53131A-07

S E R V I C E N O T E

53131A 225 MHz Counter

Serial Numbers: MY47000000 to MY47003808
SG47000000 to SG47000255

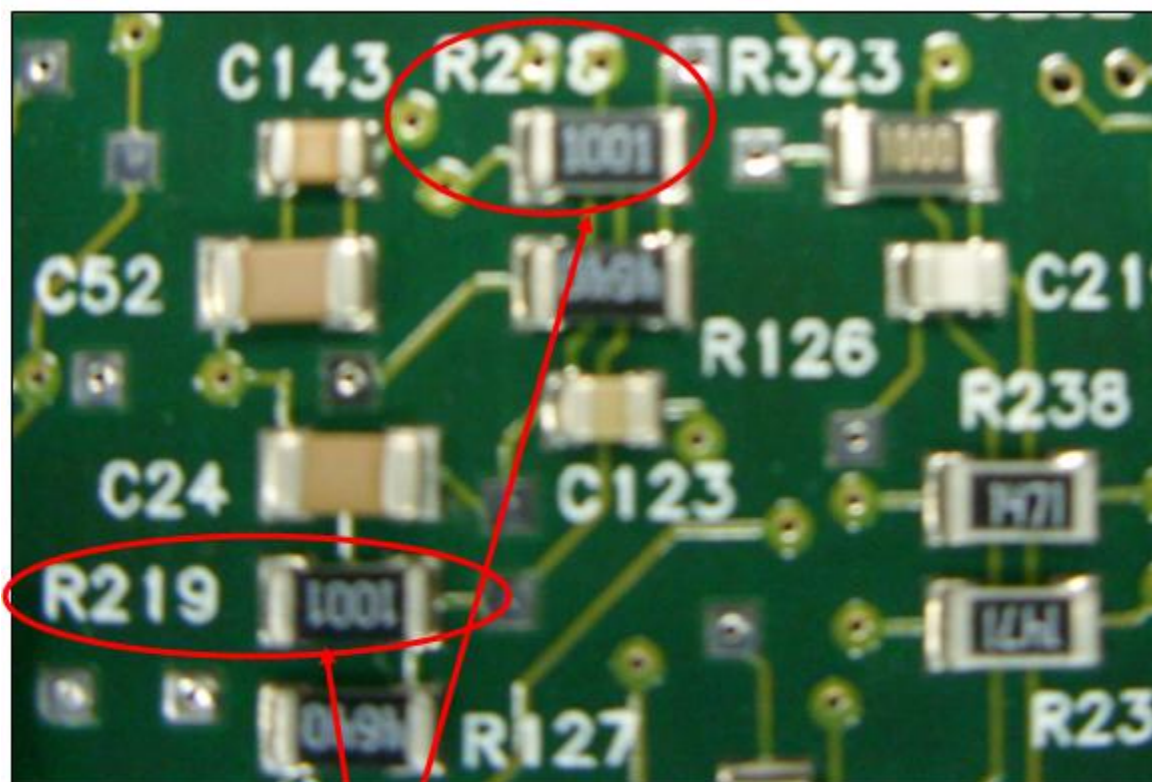
When signals are applied to both channel 1 and channel 2, under some conditions, the channel making the measurement may receive an incorrect trigger.

Incorrect triggering can occur if both channels have been configured for a measurement since the last power cycle or if large signals (> 10 Vpp) are used. The counter may use the trigger from one channel to initiate a measurement on the other channel.

Replace resistor 0699-1318 at reference designators R219 and R218 with 0699-1377 (2.37 KOhm).

Affected PCA: 53131-69004, 53132-60004
